WORK CHANGE DIRECTIVE NO.: 7

Owner: City of Greenfield
Engineer: Commonwealth Engineers, Inc.
Contractor: FA Wilhelm Co., Inc.
Project: Greenfield WWTP Improvements
Contract Name: City of Greenfield – Wastewater Treatment Plant Improvements
Date Issued: 2/22/2023 Effective Date of Work Change Directive: 2/22/2023

The intent of this work change directive is to address the procedure required moving forward to complete the excavation and subgrade preparation of the new sludge processing building.

Sludge Building – Revised General Undercutting diagram (1 page)

**SLUDGE BUILDING - GENERAL UNDERCUTTING DIAGRAM
(NOT TO SCALE)**

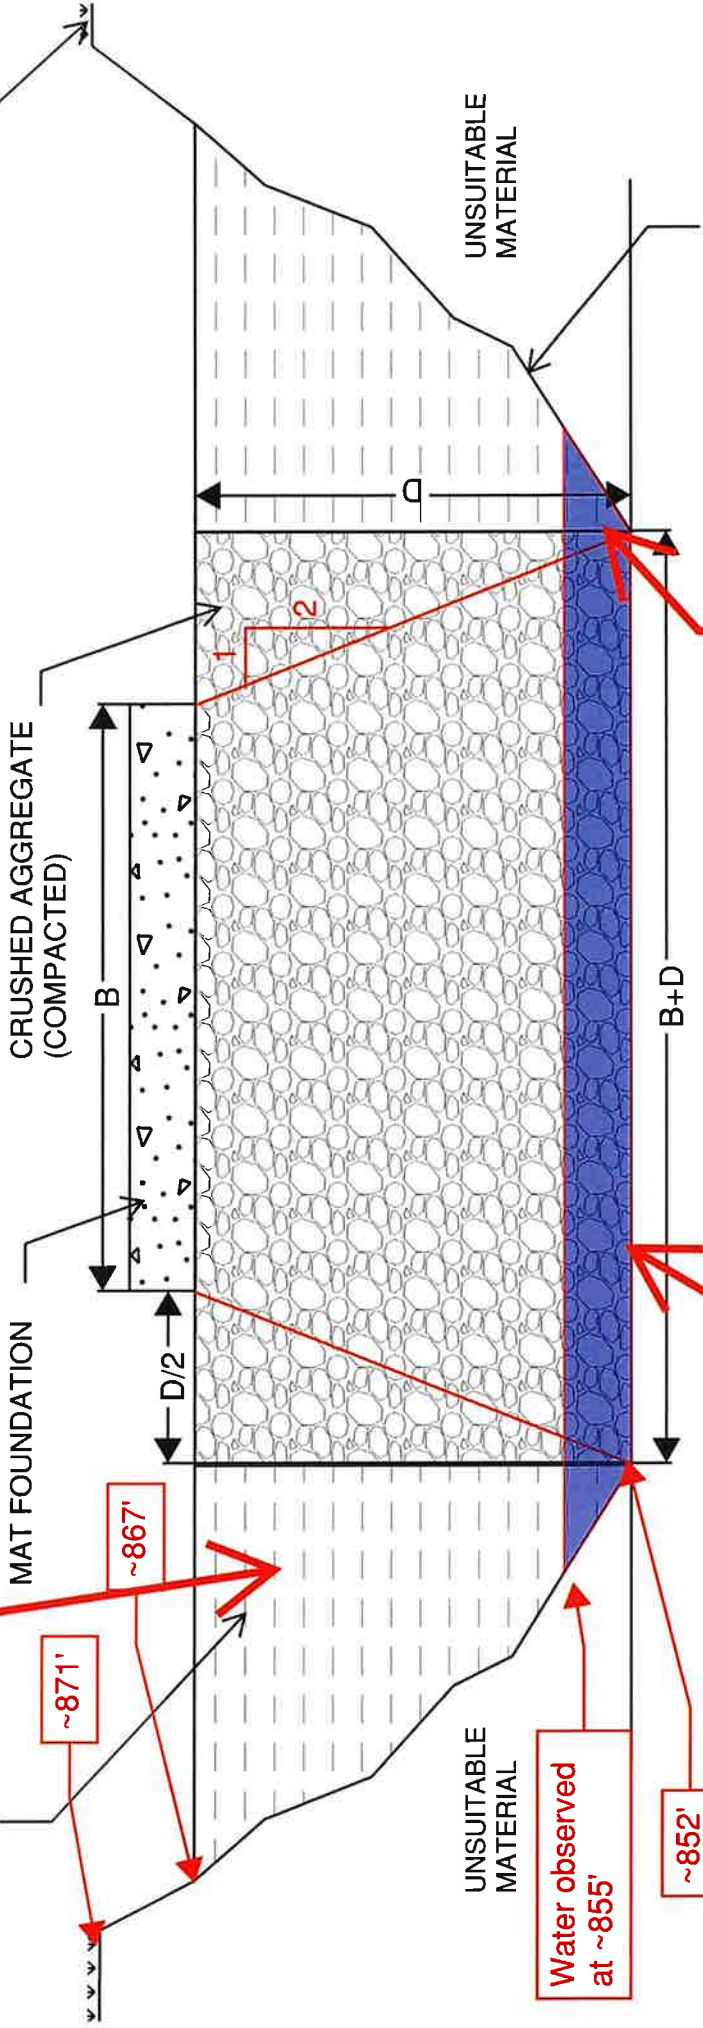
Onsite fill above clay cap can be existing "dirty" stockpile. This material cannot have solid objects or debris. If so, this is the barrier needed between stone sub grade and surrounding contaminated soils.

If needed, No. 2 stone can be used below groundwater. 2' thick layer Max.

Perimeter of excavation and between stone fill and onsite fill needs to be capped with 2' of clay (stockpile west of trailer or pump station excavation)

SLOPE IN ACCORDANCE WITH OSHA REQUIREMENTS AND FOR STABLE CONDITIONS

- Backfill will consist of:
 - Barrier layer placed in the layback area of the excavation. This material can come from the onsite pile west of trailers or the Influent Pump Station excavation.

- #53's beneath the building footprint and extending vertically at 10' (or D/2 if deeper than 20' total D) beyond (all sides) the building foundation.

- Material from the adjacent “dirty” pile will be placed in the excavation layback if it is free from trash and debris.
 - If water is encountered, #2 stone can be used in the saturated area to eliminate the need to compact #53s in water. This layer cannot exceed two (2) feet in thickness.
